# PEFT, LLC

**To: University of Michigan**

RE: Proposed Valhalla Site Plan, City of Ann Arbor

**Stormwater Management Plan (as currently designed and approved in accordance with the current rules of the WCWRC).**

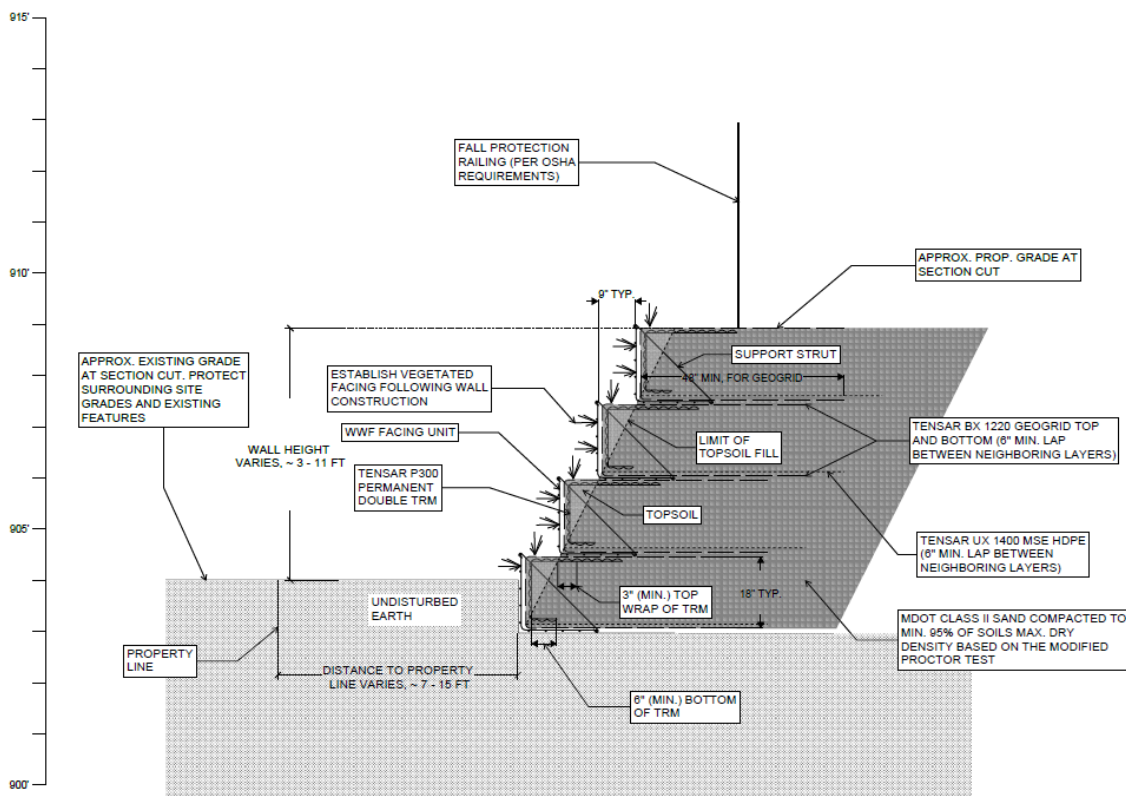
What follows is an update on the details of the design as they relate to the questions and concerns previously expressed from the University of Michigan personnel:

- *Additional Stormwater detention*
  - *This design incorporates holding/detaining a volume of 120% of a 100 - year storm event where as the site currently has no stormwater management*
  - *There is additional free-board stormwater volume provided above the 100-year volume.*
  - *Proposed green roofs and bio-retention areas provide additional stormwater volume*

- The stormwater pumping station will have power redundancy with its own emergency back-up generator, therefore functionality is maintained during power outages
- Duplex pumps will be provided in the pump station to maintain mechanical redundancy and functionality if one of the pumps fail (any pump failure will trigger an alarm). Pumping station will be maintained by the city.

**SECTION A-A': MSE SLOPE (TYP. DETAIL)**

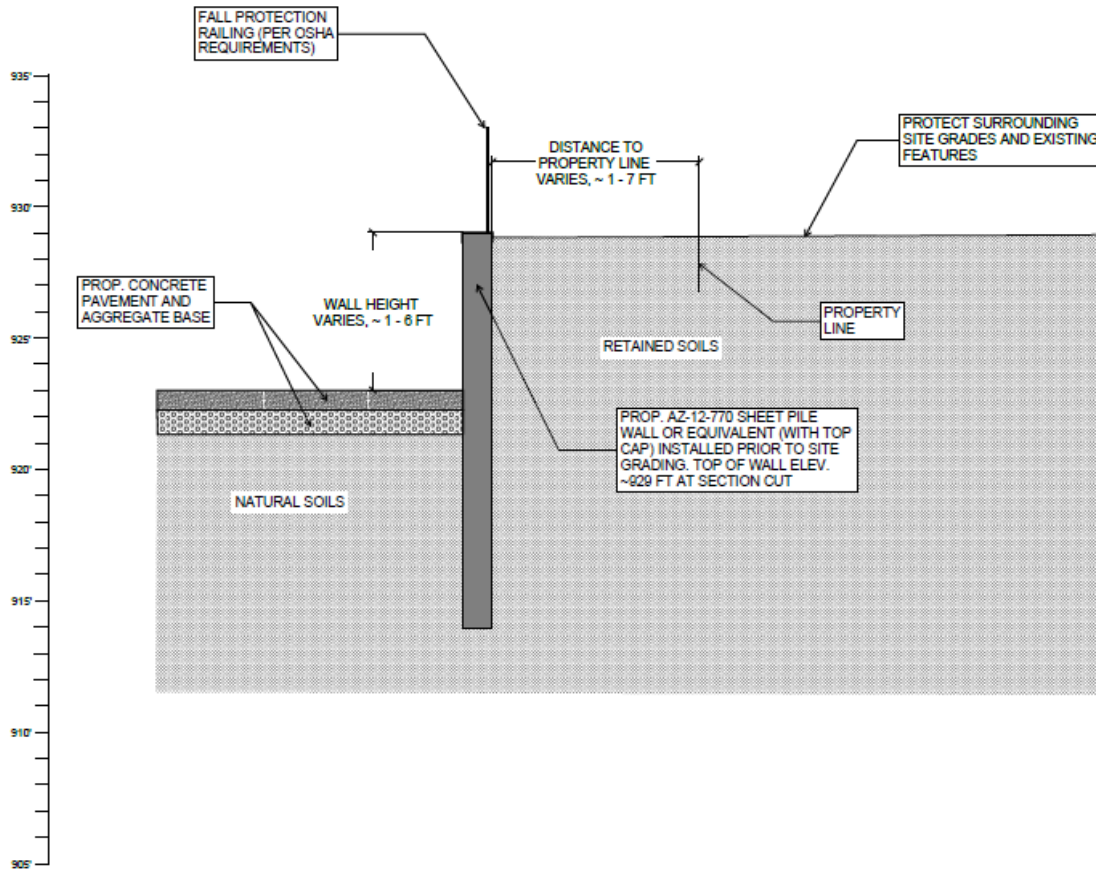
**Retaining walls will be constructed on the development's property and not require easements from the University of Michigan.**

*SME has been added to the team to provide geotechnical services on the project. SME, Atwell and McIntosh Portis have been working together to further detail the proposed retaining walls and grading on the site.*

*The retaining wall on the north side of the property is proposed to be a Mechanically Stabilized Earth (MSE) system - see image below for conceptual design*
